<b>RELEASE DATE:</b>	14/06/2024
<b>EFFECTIVE DATE:</b>	08/07/2024
<b>SUBJECT:</b>	Foam removal from Sling 4 TSi parachute box
<b>MODELS AFFECTED:</b>	All Sling 4 TSi's that have a Magnum 901 Parachute installed. (For ready to fly aircraft, up to SN 560s, where applicable)
<b>COMPLIANCE TIME:</b>	Next MPI (Mandatory Periodic Inspection) or annual inspection, whichever comes first.
<b>LABOUR TIME:</b>	2.5 hours

**1. DESCRIPTION AND PURPOSE:**

Figure 1: Blowout skin rivets to remove.

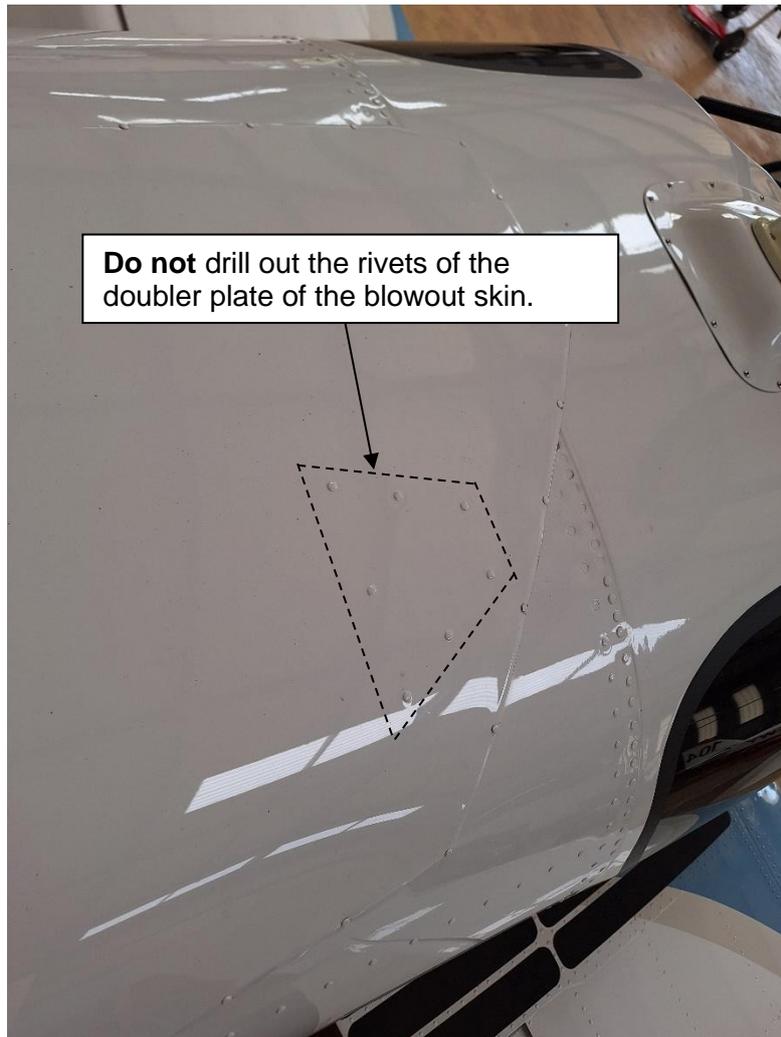
Step 1: Drill out the rivets retaining the parachute blowout skin. Refer to Figure 1 and Figure 2. It is important to not enlarge the holes while drilling out the rivets. Use the punch to mark the centre of the rivet head to make it easier to line up the drill bit with the centre of the rivet.
